Town of Parker Community Development Department  
Development Review Division  
Attention: **BrieAnna Simon**

Application Type: **Site Plan**  
Status: **First Referral**  
Application Name: Lot 1 Block 1 Horseshoe Ridge - Learning Experience SP  
Case/AP#: **SP19-061**  
Referral Received: June 19, 2019  
Comments Due: July 18, 2019

Review date: **July 12, 2019**  
Plan reviewer: **Randall L. Capra**, [rcapra@parkeronline.org](mailto:rcapra@parkeronline.org)  
Phone: 303.805.3169

**TOWN OF PARKER - FIRE/LIFE SAFETY:**

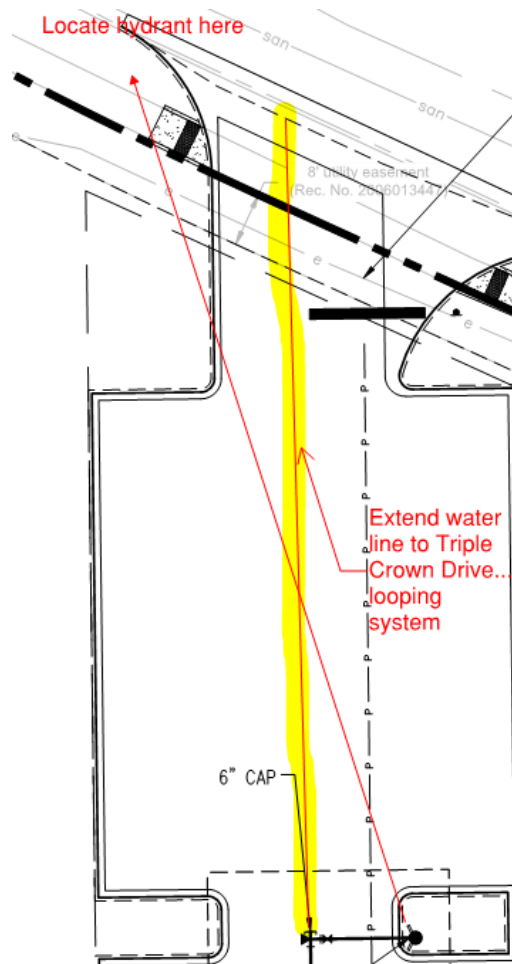
7. **The applicant had indicated that the UFL and the fire hydrant are to share a dead end water main; the applicant shall revisit the submittal and place the fire hydrant on its own tap. The UFL and the fire hydrant are not allowed to share the same line. Not Satisfied; the water main, located on the south side of the building shall be looped/extended to Triple Crown Drive with the fire hydrant that was located on the n/w corner of the building, located at the n/w corner off of Triple Crown (see below). Address this issue when resubmitting. Satisfied; applicant has addressed with the fourth submittal.**
